Product Change Notification / LIAL-26JIWI938

CCB 5172 Initial Notice: Qualification of UTL as a new assembly site for MICRF112YMU-TR catalog part number (CPN) available in 10L X2DFN (2x2x0.4mm) package.

QUALIFICATION PLAN SUMMARY

Pre and Post Change Comparison

CCB#: 5172
Pre and Post Change Summary
PCN #:LIAL-26JIWI938

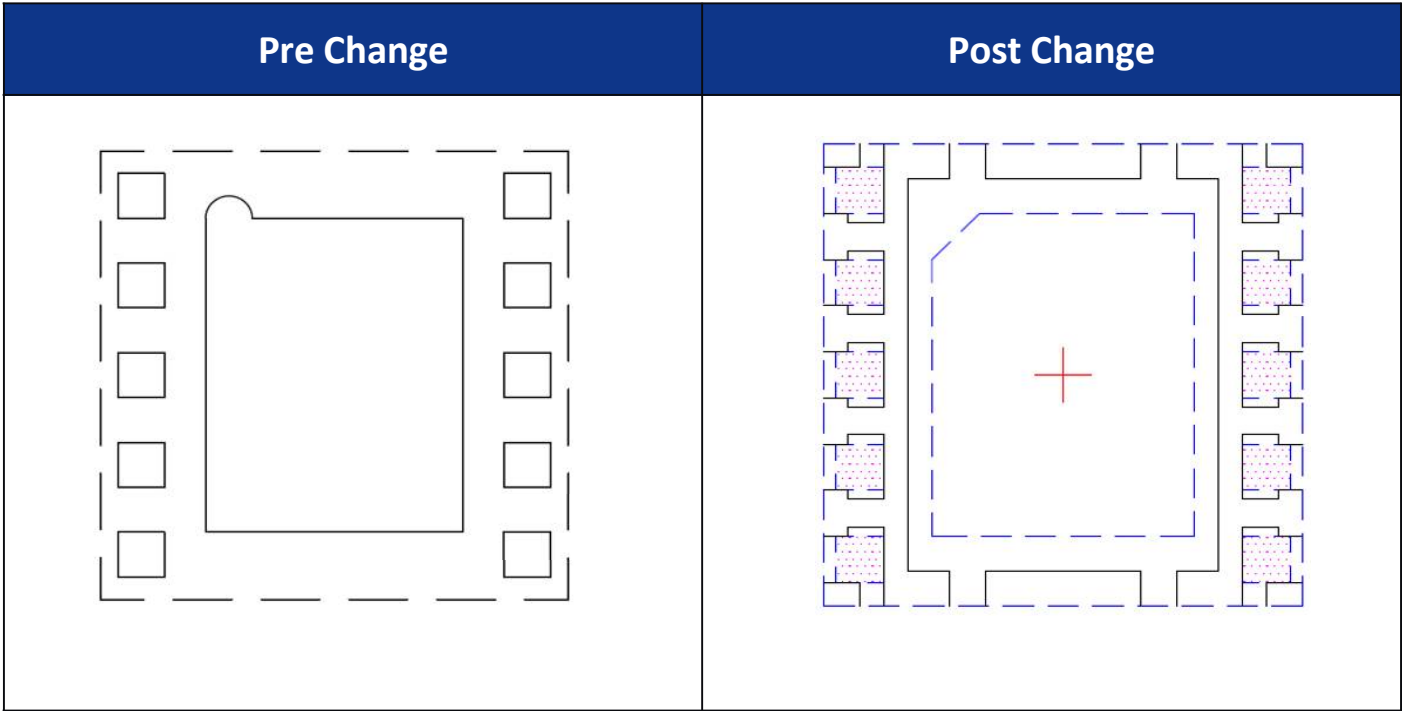
Description of Change:Qualification of UTL as a new assembly site for MICRF112YMU-TR catalog part number (CPN) available in 10L X2DFN (2x2x0.4mm) package.
